> Date: August 20, 2018 Sale Name: Super Cooper

Contract No.: ORN04-TS-2018.0403

# **CORRECTION NOTICE**

#### CORRECTED PROSPECTUS

Super Cooper Timber Sale Contract No. ORN04-TS-2018.0403 Exhibit E Page 5 of 7

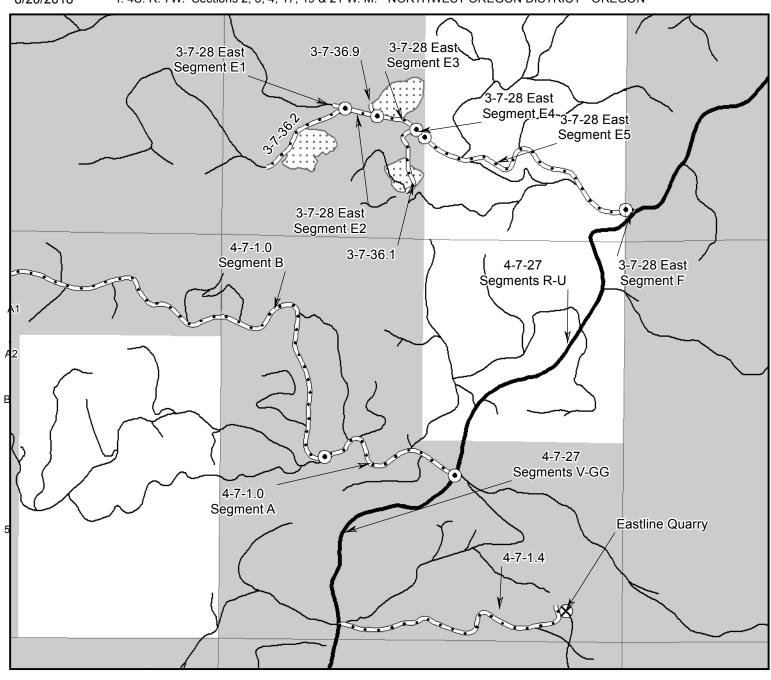
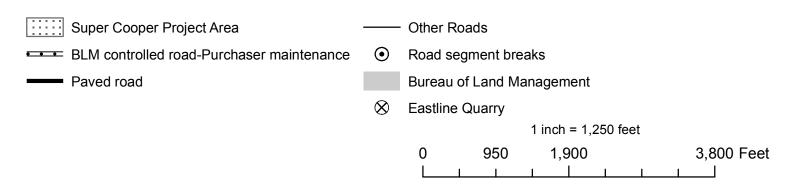
The Exhibit E Maintenance and Access Map, page 5 has been corrected to mark 4-7-1.4 (Eastline Quarry Road) as a BLM controlled road with purchaser maintenance.
